**OUCG COMMENTS ON
2019 INTEGRATED RESOURCE PLAN OF
INDIANAPOLIS POWER & LIGHT COMPANY**

*Indiana Office of Utility Consumer Counselor's
April 15, 2020 Comments on IPL's 2019 IRP*

Figure OUCC – 1

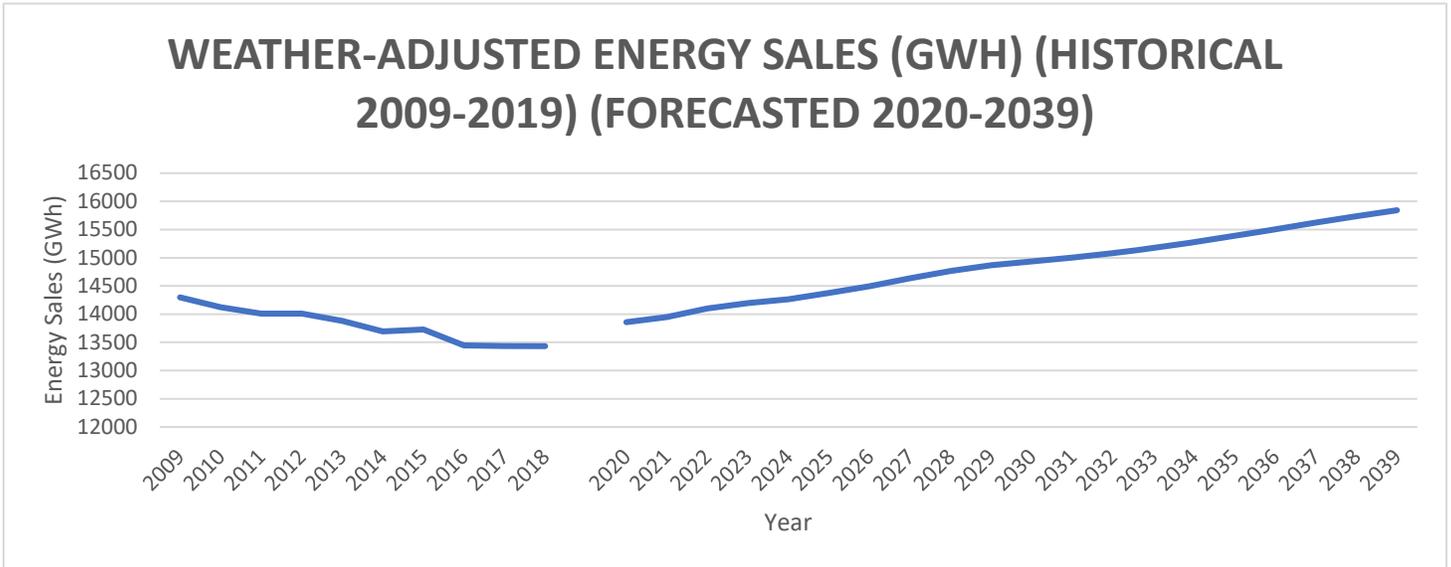
If IPL's over-forecasting trend continues in its 2019 IRP, it would cause IPL to build too much new capacity, thereby causing utility rates to be unreasonably high. Figures 4.28 and 4.29 in IPL's IRP show consistently high demand and energy sales forecasts for many years.

Attached Figures OUCC-1, OUCC-2, OUCC-3, and OUCC-4 show a nearly unbroken string of reductions in IPL's actual demand and energy sales over the past decade, while also showing a nearly unbroken string of forecasted increases in demand and energy sales over the next two decades. Attached Figures show in almost every year over the past decade IPL forecasted growth in demand and energy sales in each subsequent 5-year period, but demand and energy sales actually declined in each of those 5-year periods. The most recent forecast (2017) for which we have weather-adjusted actual data is the only forecast predicting a reduction in energy sales (although that year's forecast predicted growth in demand for 2018). To summarize, IPL has almost exclusively forecasted growth in weather-adjusted demand and energy sales, but has consistently experienced reductions in weather-adjusted demand and energy sales. While energy efficiency measures - especially LED light bulbs - have grown in penetration over the past decade, it is unclear why expectations for such growth were not incorporated into IPL's IRP modeling process to improve the subsequent demand and energy sales forecast accuracy.

IPL has not provided any analysis to show or explained why its past projections have consistently over-forecasted these variables. IPL should perform a critical analysis of its forecasting methodology before making decisions about future capital investment or retiring its generating plants early. Another issue the OUCC identified in evaluating IPL's load forecasting model is an unrealistically high level of expected real income growth in its service territory over the next 20 years. IPL's forecast predicts Marion County's average real annual income will grow by 2% every year for the next 20 years.¹ This is more than double the growth seen by the 90th percentile of income earners in the U.S. from 1979 to 2018.² All else being equal, income growth increases electricity sales. IPL's high expectation for growth in real income may partially explain IPL's historical tendency to over-forecast sales. IPL should evaluate this issue as part of its comprehensive forecasting methodology review.
